# Periodic checking of the crankshaft journal (power take off side) for ROTAX® Engine Type 912 and 914 (Series)

ATA System: 72-20-00 Engine block

## MANDATORY

**Fig. 1**  
**Crankshaft journal**

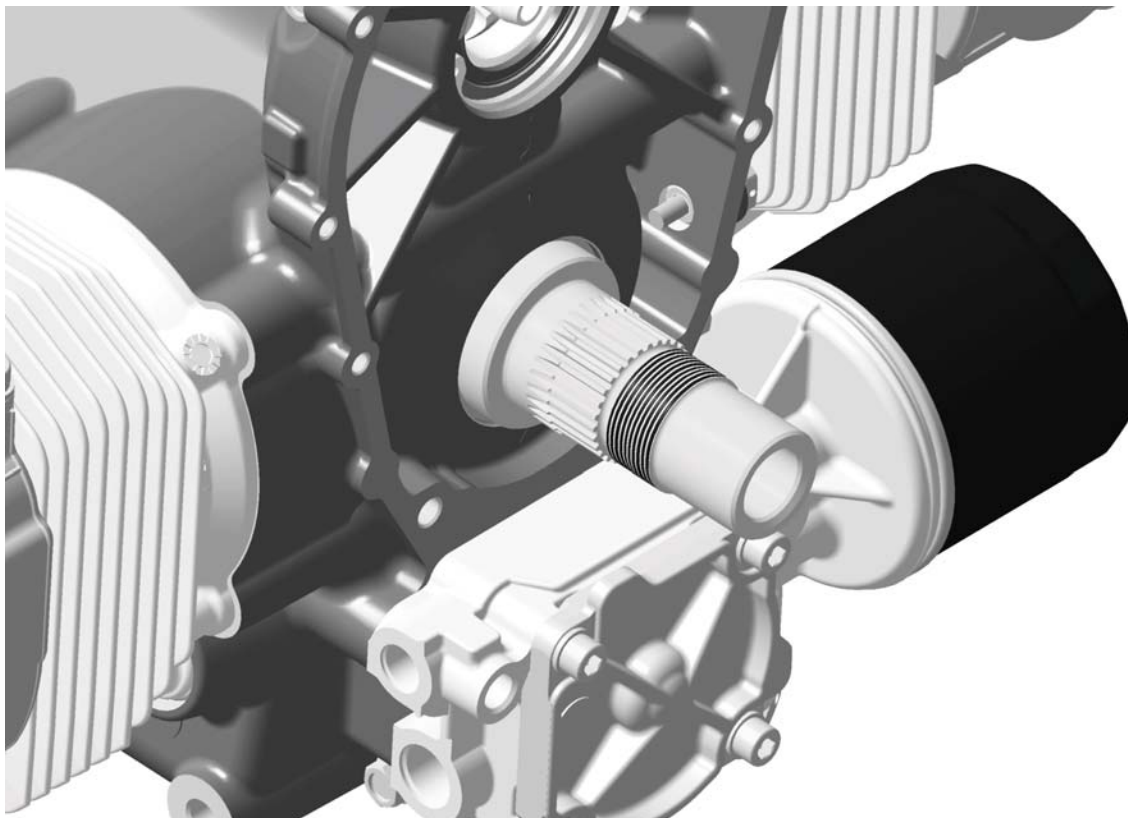
Due to a deviation in the manufacturing process some crankshafts may develop a crack on the power take off side. These cracks can cause breakage of the crankshaft in the support bearing during operation. In this case the function of the support bearings (consisting of 3 main bearings and 2 support bearings) is compromised. The operating reliability, however, is given until the next maintenance.

### 3.1) Checking of crankshaft journal (power take off side)

See Fig. 1, Fig. 2, Fig. 3.

**Fig. 2**  
**Inspection with feeler gauge**

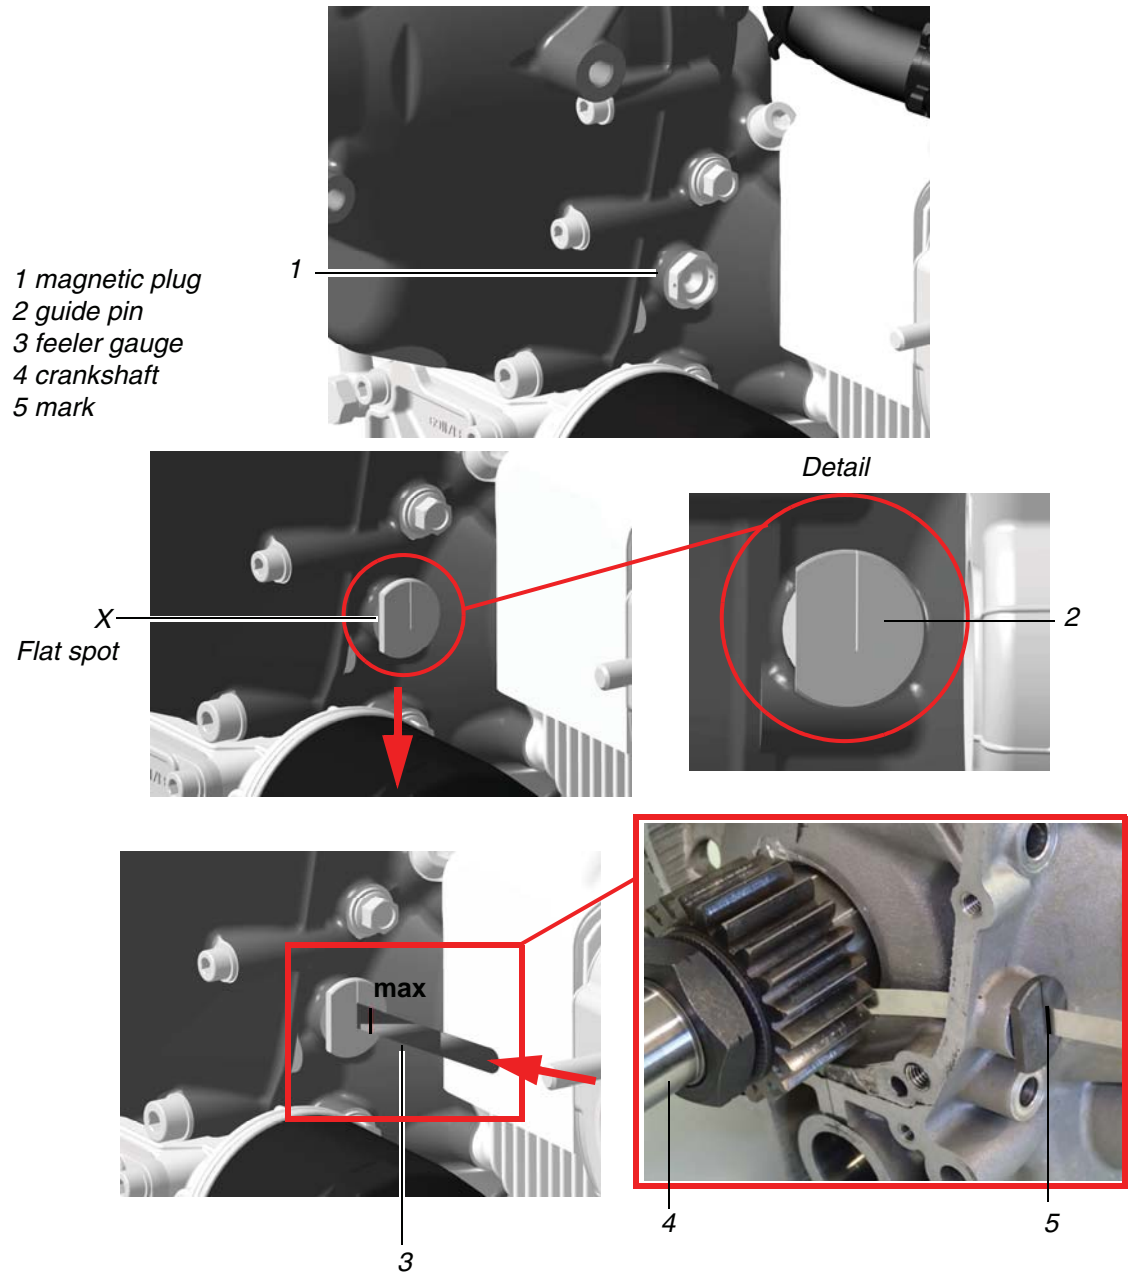
Step	Procedure
1	Remove the magnetic plug in accordance with the relevant Maintenance Manual (Line).
2	Install guide pin (2) of the check gauge CS-PTO into the magnetic plug thread until stop. Adjust the guide pin with the flat spot (X) in the direction of the propeller and parallel to the gearbox/housing contact surfaces. Hold it in fixed position not allowing any rotation. Pliers or an open-end spanner can be used.
3	Insert feeler gauge of check gauge CS-PTO into the guide pin. NOTE: The feeler gauge is symmetrical, both sides can be used.
4	Insert feeler gauge until a first resistance can be felt. Now the feeler gauge faces the cylindrical crankshaft journal (see Fig. 3, Step. 1).
5	With slightly elevated force you can push the feeler gauge about 2 mm (.078 in.) further in, until it touches the plan surface of the pinion gear (see Fig. 3, Step. 2). NOTE: The mark on the feeler gauge is still visible outside the slot.

Step	Procedure
6	Push the check gauge into the guide pin with increased force and make sure that the guide pin has not turned. If the drive gear is in correct position and cannot be moved the crankshaft is OK. The feeler gauge cannot be further moved in and the mark (5) remains visible outside the slotted screw.
<b>Result = Crankshaft journal OK</b>	
7	Remove the check gauge CS-PTO (feeler gauge and guide pin).
8	Install the magnetic plug in accordance with the relevant Maintenance Manual (Line).

Fig. 3

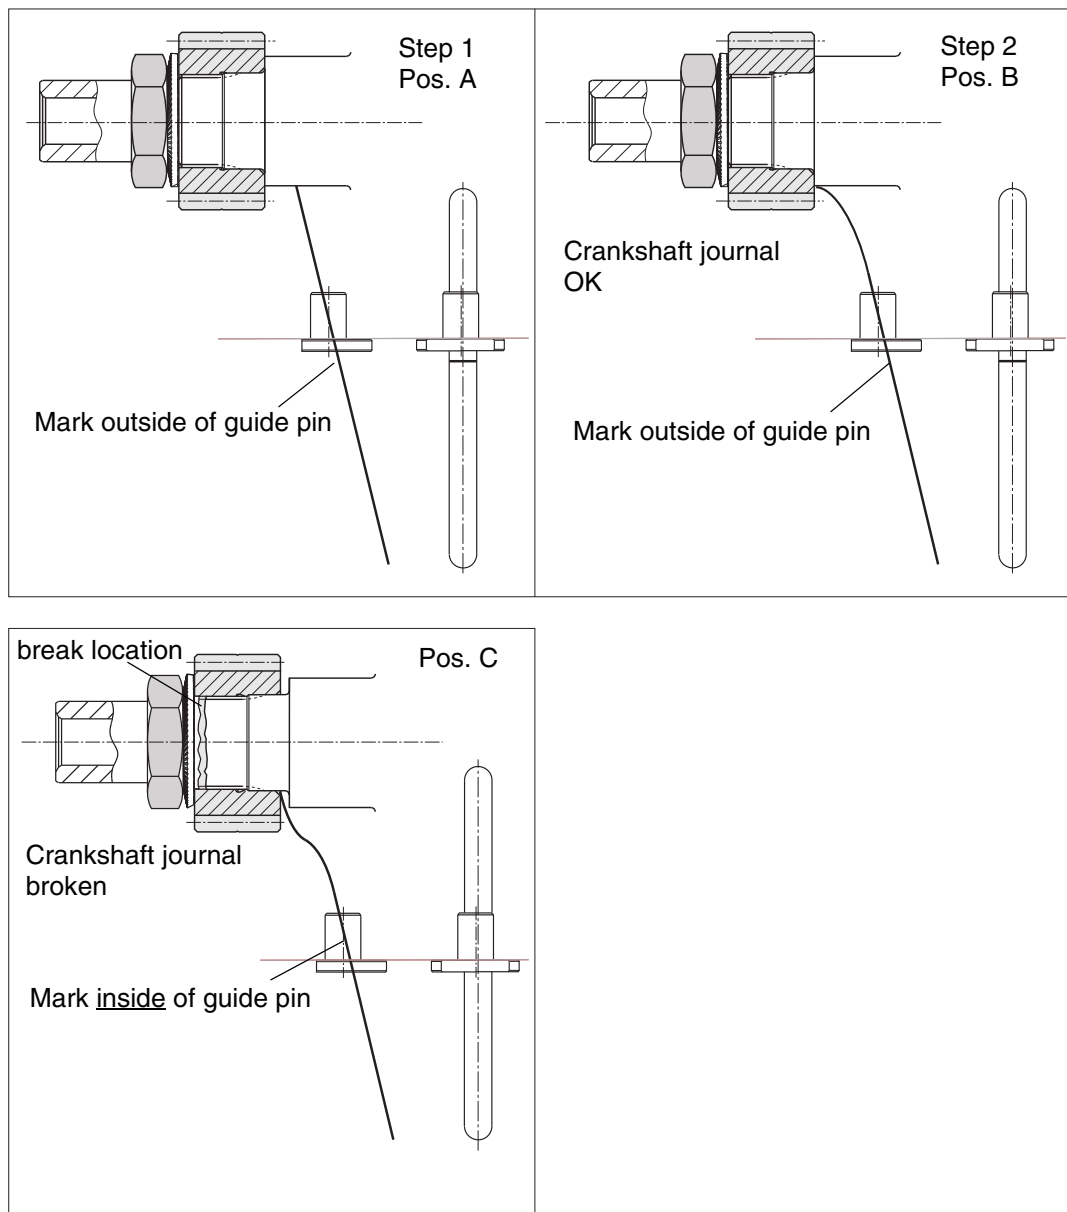
Step	Procedure
6	Hold it in fixed position not allowing any rotation. If the feeler gauge can be pushed further in, so that the mark disappears in the slot, then the gearbox must be removed and the crankshaft must be checked (see Fig. 3, Pos. C).
<b>Result = Crankshaft journal broken</b>	
7	Please find further explanations if needed in this chapter 3.2).

The replacement of the crankshaft is only necessary, if inspection result 2 is applicable.

- In case of a broken crankshaft journal or any doubt contact your aircraft manufacturer and your nearest authorized ROTAX® aircraft engine distributor.
